PUBLIC UTILITY COMMISSION OF OREGON  
STAFF REPORT  
SPECIAL PUBLIC MEETING DATE: March 16, 2020

**SUBJECT:** PORTLAND GENERAL ELECTRIC:  
(Docket No. LC 73)  
Acknowledgement of 2019 Integrated Resource Plan

**STAFF RECOMMENDATION:**

**Figure 1: Renewable Resource Portfolio Additions<sup>84</sup>**

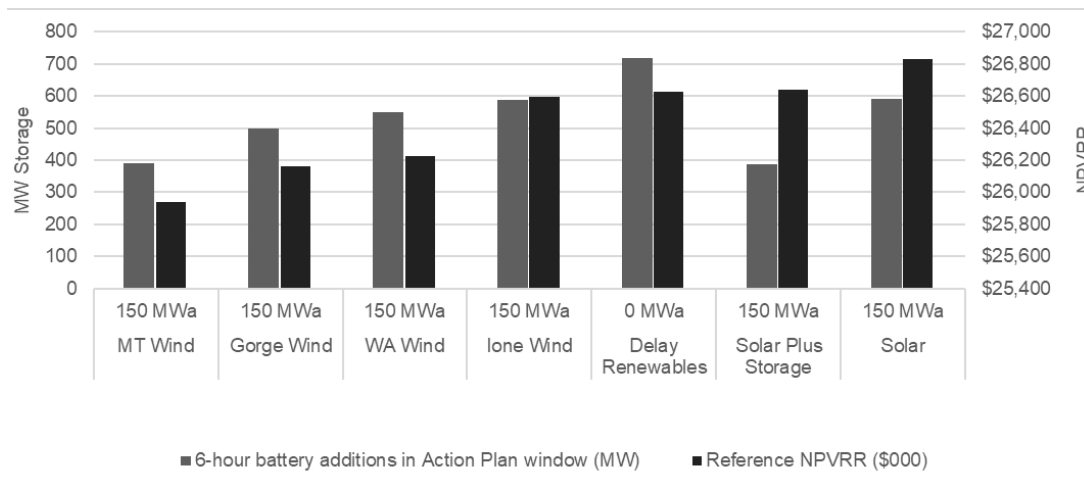
Examination of PGE’s renewable resource portfolios shows that the optimal dispatchable capacity resources—as well as the portfolio’s performance—is closely linked to the attributes of the renewable resources acquired. For example, the portfolio constrained to add 150 MWa of Gorge Wind requires 50 MW fewer in storage capacity additions and provides \$64.5 million of additional benefits compared to adding 150 MWa of Washington Wind.

However, the Washington Wind proxy resource performs notably better than the Gorge Wind on an energy and net resource value basis (roughly 22 percent). This enforces Staff concern that separately pursuing energy resources based on the forecasted energy value places ratepayers at an even higher risk of overbuilding across resources.

**Figure 2: PGE 2017 Proposed Renewable Glide Path**

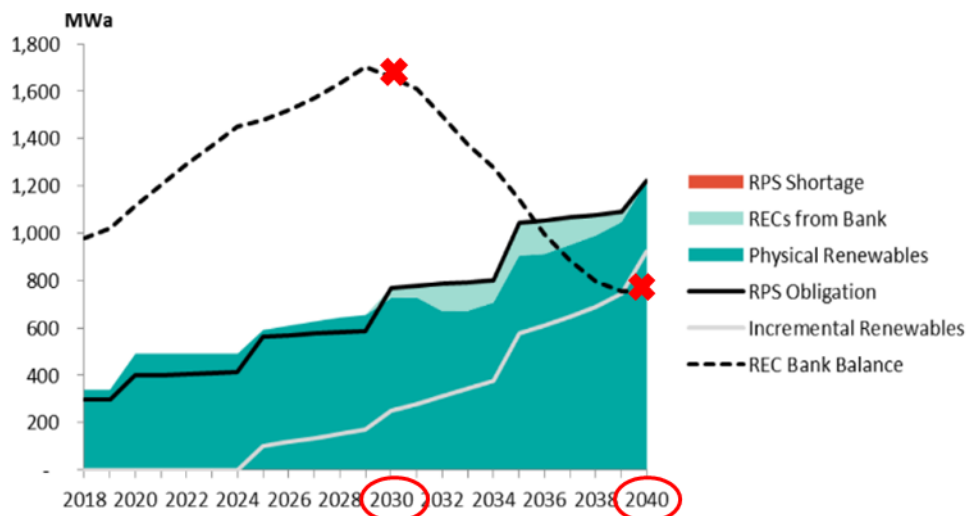
PGE's proposed physical compliance strategy is a large departure from the last IRP. In LC 66, PGE proposed a mix of RECs and near-term resource acquisitions to create a glide path for long-term RPS compliance, as shown in the figure below.<sup>148</sup>

PGE's proposed shift to a physical compliance strategy in the 2019 IRP nearly doubles the forecasted REC bank size by 2030, and by 2040 the REC bank is about seven times larger than the glide path proposed in 2017.<sup>149</sup> For perspective, PGE will have roughly four times as many RECs in its bank than its reference case load forecast in 2040. This means PGE could have enough RECs stored up—already paid for by ratepayers—to meet eight years' worth of its 50 percent RPS obligation.<sup>150</sup>

**Figure 3: PGE 2019 IRP Preferred Portfolio REC Utilization<sup>151</sup>**

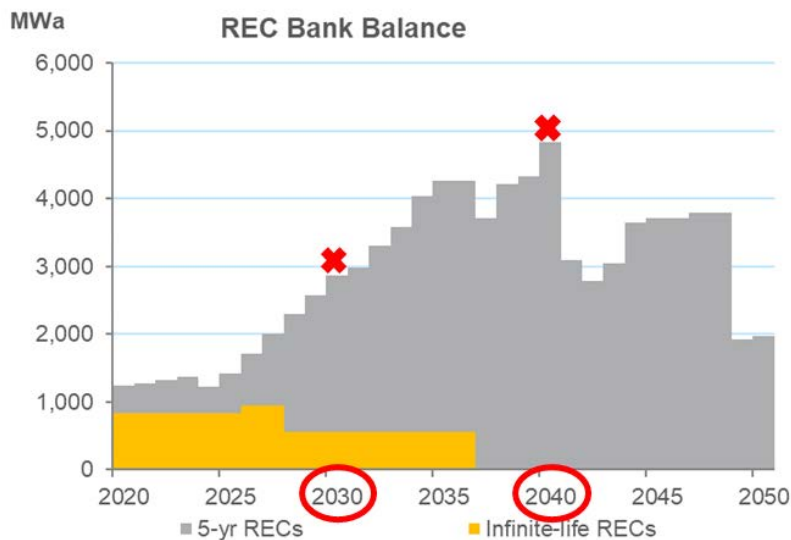
Staff appreciates all of the additional analysis conducted by PGE on issues related to RPS need and its physical compliance strategy. However, we agree with AVEC that this approach overstates the near-term need for PTC wind in an effort to help bolster the more long-term and thus less concrete benefits related to the economic opportunity argument associated with this resource. In this sense, we disagree with the analysis of NVEC, RNW, and CUB.

PGE presents analysis clarifying that the model can still choose to use banked RECs. However, the physical compliance requirement means that the use of banked RECs cannot actually defer the model's decision to add new resources—it simply determines which RECs are most cost-effective to retire. To this end, if renewables are projected to be so much cheaper than banked or unbundled RECs, then Staff is left wonder why the physical compliance requirement was necessary in the first place.

**Figure 4: Historic Commercial and Industrial Load<sup>168</sup>**

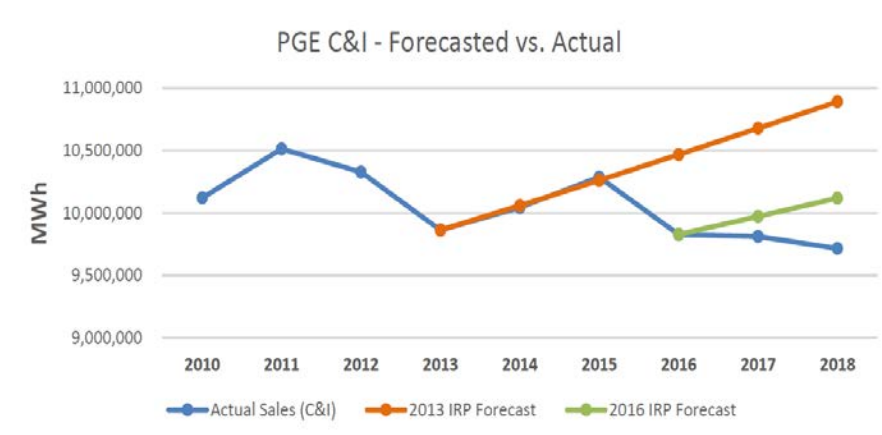
load growth of 0.5 and 1.9 percent for commercial and industrial customers stands in contrast to recently observed annual growth rates.
